PHASE II

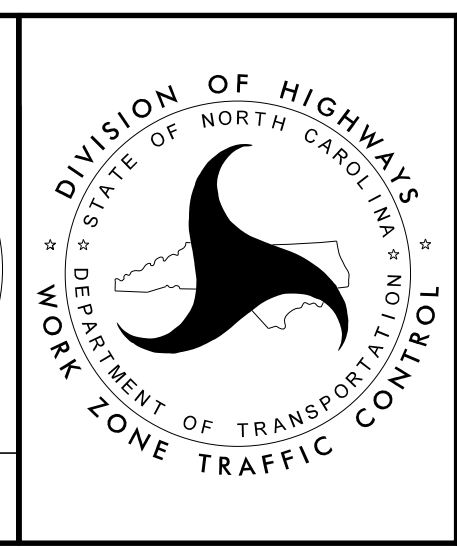
USE A 1:1 (H:V) SLOPE OR FLATTER INSTEAD OF TEMPORARY SHORING FROM -L- STA. 13+09± 17.5' RT, TO STA. 13+25± 21' RT.
